**REQUEST FOR TENDER
BIRD/SNOW LEOPARD MESH ENCLOSURES
RFT #39 (2013-07)**

ADDENDUM # 1

RFI 62 REQUEST FOR INFORMATION

10 Curb to Cable Transition

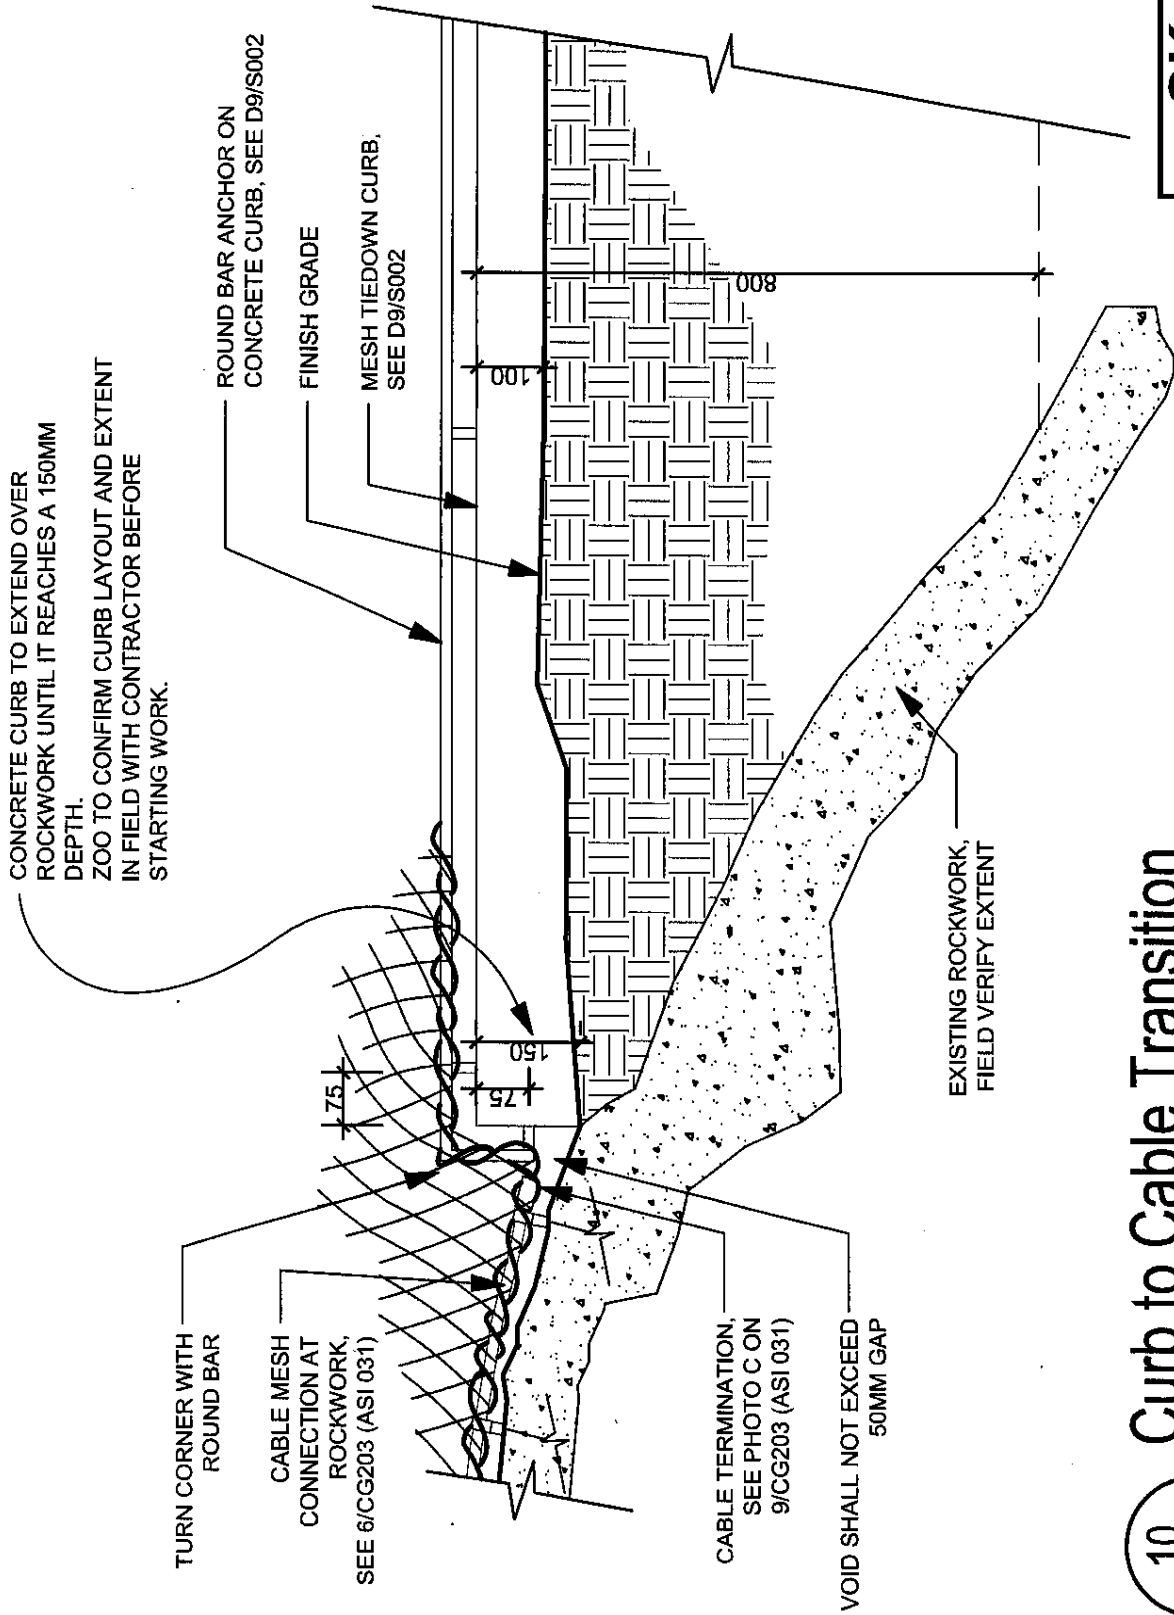
<p>INFORMATION REQUESTED (ATTACH EXTRA SHEETS IF NEEDED): Snow Leopard Enclosure – Rockwork/Curb Detail</p> <p>The following details are required:</p> <ol style="list-style-type: none"> 1) A detail showing the transition between the Snow Leopard curb and rockwork where the curb is shown to extend into the rockwork. Does the contractor cut the rockwork and run the curb into it? 2) A detail is required at transition point where the curb detail meets the rockwork detail. In particular where the rockwork stranded cable detail meets the curb steel rod detail. <p>RESPONSE / RECOMMENDATION (ATTACH EXTRA SHEETS IF NEEDED):</p> <p>1 & 2) See SK-01 attached showing transition condition and termination of curb into rockwork. Contractor shall verify extent (termination location) of curb in field with Zoo.</p>
--

Mesh tie down at transition included as part of this tender.
